Re: New Cassel Industrial Area

## **Technical Comments Regarding US EPA's Proposed Pre-Design Investigation Statement of Work New Cassel/Hicksville Groundwater Contamination Superfund Site**

This document presents technical comments on the US EPA proposed Pre-Design Investigation (PDI) Statement of Work (SOW) for Operable Unit 1 (OU1) of the New Cassel/Hicksville Groundwater Contamination Superfund Site (Site; Figure 1). The PDI is based on a flawed Conceptual Site Model (CSM) that: 1) incorrectly concludes that the extent of the OU1 Eastern Plume is spatially limited by ignoring available data and US EPA's own contractor's conclusion (see Figures 2 and 3 – reproduced from EPA's contractor's memorandum; Lockheed Martin, 2013),<sup>1</sup> which show that the plume continues to migrate a significant distance to the west; and 2) ignores that the plume that originates upgradient of the NCIA (Upgradient Plume) is continuing to migrate into OU1. These critical CSM deficiencies have previously been presented in detail to US EPA in comments to the Proposed Remedial Action Plan (PRAP) filed by IMC Eastern, Corp. (Gradient, 2013)<sup>2</sup> and in prior comments to US EPA regarding the p

FIGURE  
7

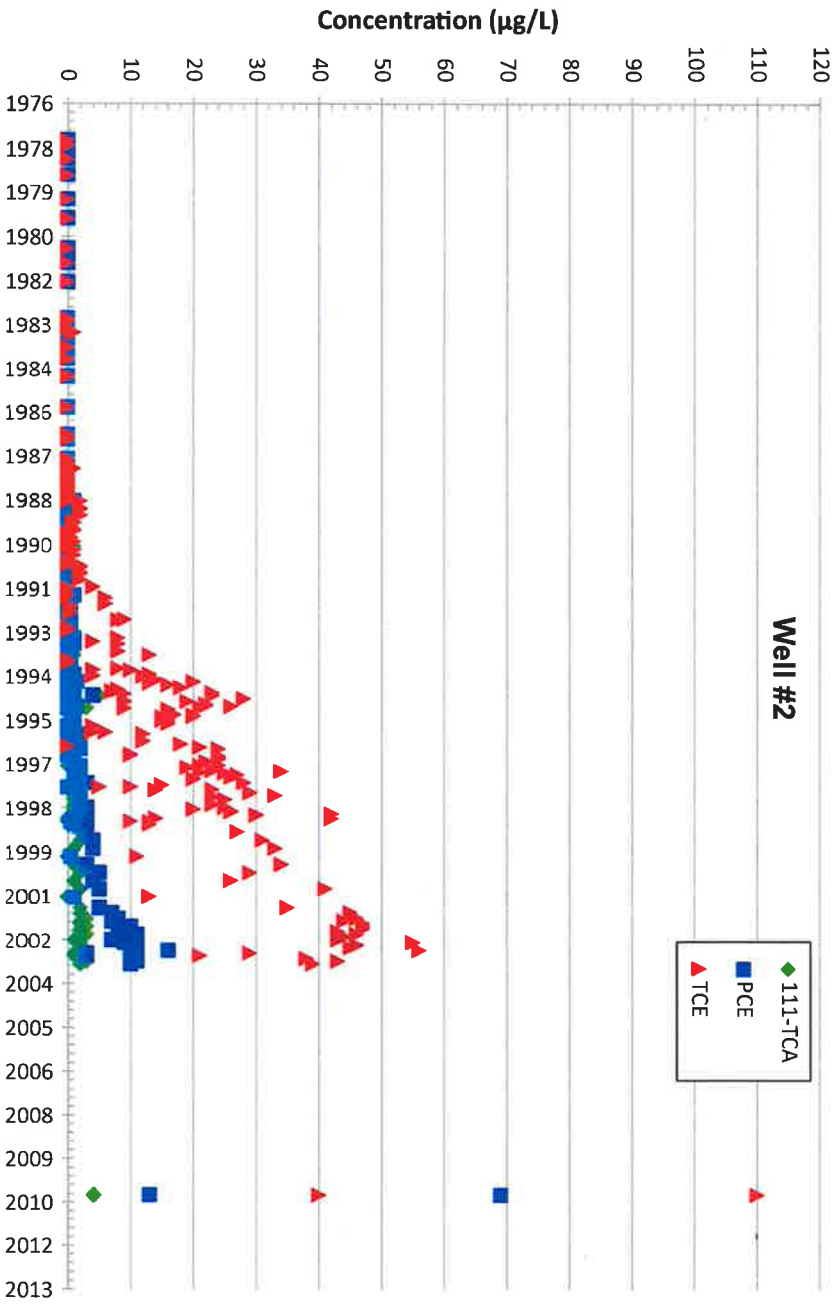
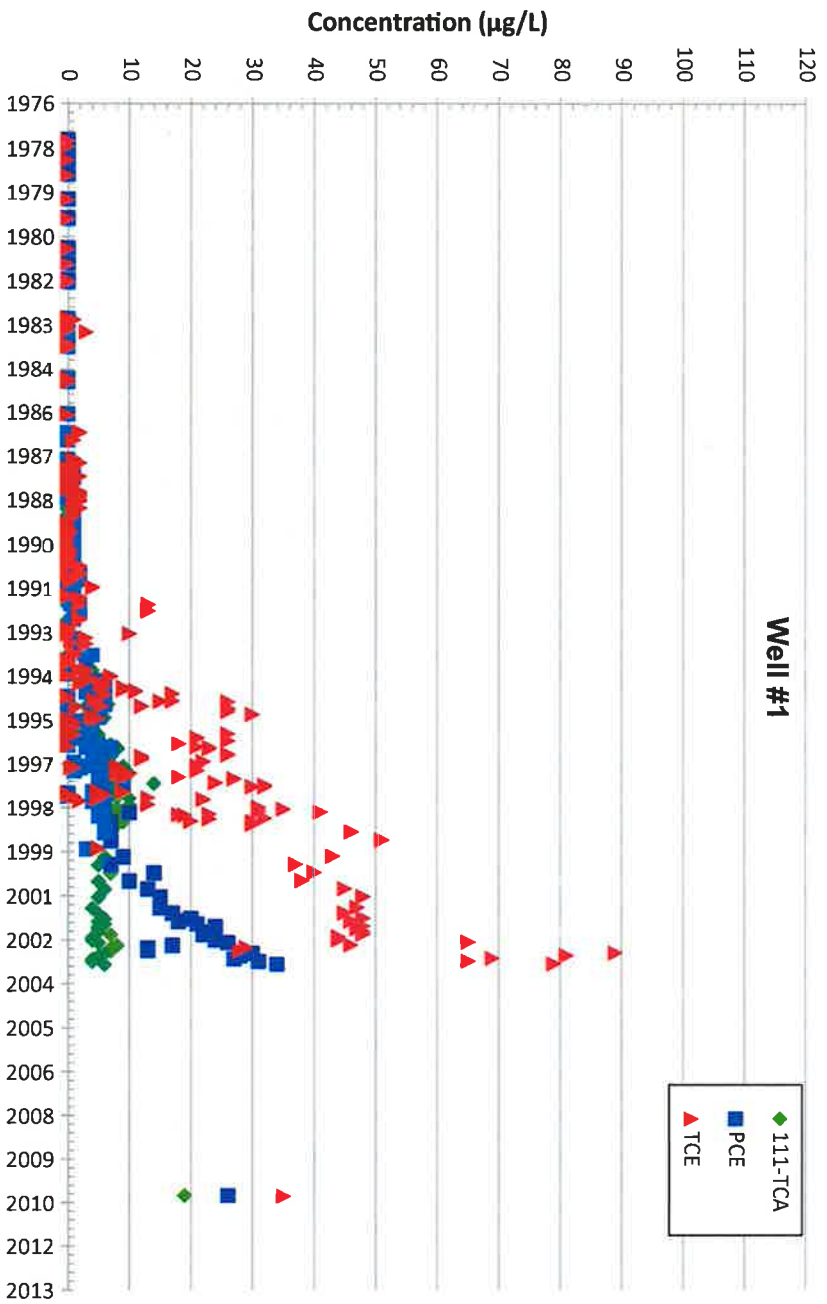
Additionally, historical data demonstrate the southwestern migration of the Eastern Plume within OU1. At the Bowling Green Water Supply Wells (Figure 5), total chlorinated volatile organic compound (CVOC) concentrations have been in excess of 100 µg/L since approximately 2002 (Figure 7). Contaminants detected at the highest concentrations at these wells are PCE and TCE, constituents associated with the Eastern Plume. PCE and TCE have also been detected at nearby sentinel wells, EW-1B and EW-1C.<sup>7</sup> These data further demonstrate that the Eastern Plume has migrated to the southwest, well beyond the limited extent depicted by US EPA.

In order to design an effective remedy it is critical that additional vertical profiling be conducted in the area of TMW-8D and in the area of the Bowling Green well field (see central cross-hatched area on Figure 4) to fully define the extent of the Eastern Plume. However, no such data collection is proposed in the PDI SOW. If these data gaps are not addressed, a significant portion of the Eastern Plume will not be delineated and will not be addressed effectively by the proposed remedy.
